SERVICE BULLETIN

APPLICABILITY: 2015-2017MY WRX
2014-2017MY Forester Turbo

NUMBER: 09-65-16R

SUBJECT: Fuel Injector Design Change to Prevent
Water Intrusion

PRODUCTION CHANGE INFORMATION:

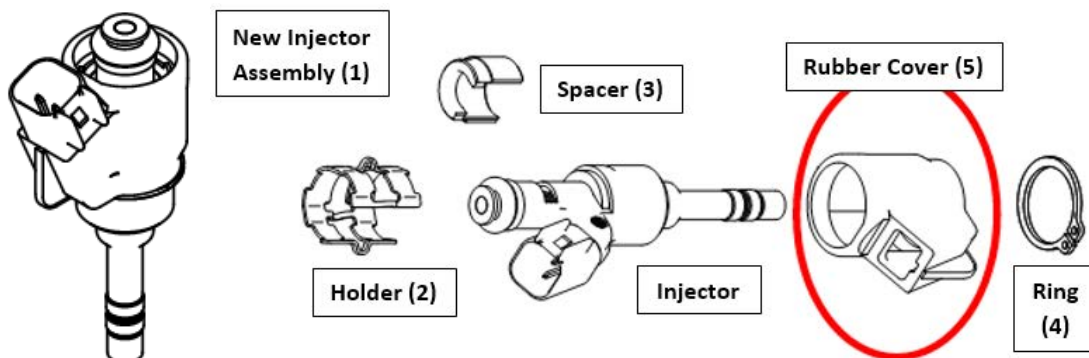
This bulletin announces a design change of the fuel injector used on 2.0L DIT models to prevent water intrusion. A new silicone rubber cover has been developed and incorporated into production for this purpose.

The new injectors were incorporated into production per the table below:

Vehicle / Model	Starting VIN
WRX	H*811518
Forester	H*427213

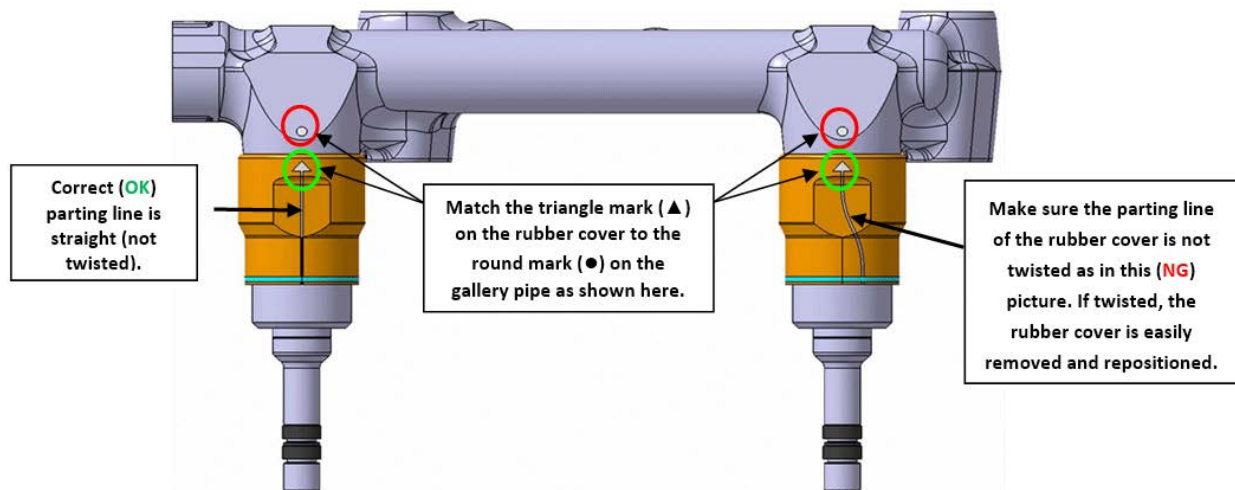
NOTE: The parts table below for new-style injectors is provided for reference only. The silicone rubber cover (5), ring (4) and spacer (3) are not intended for retrofit to old injectors.

- These parts may ONLY be used to repair p.n. 16600AA030 injectors that came equipped with the silicone rubber covers. As an example, the covers should be replaced if they become swollen or distorted due to exposure to an incompatible fluid (e.g. brake fluid).
- They must NEVER be used in an attempt to retrofit older injectors which did not come equipped with these covers originally.
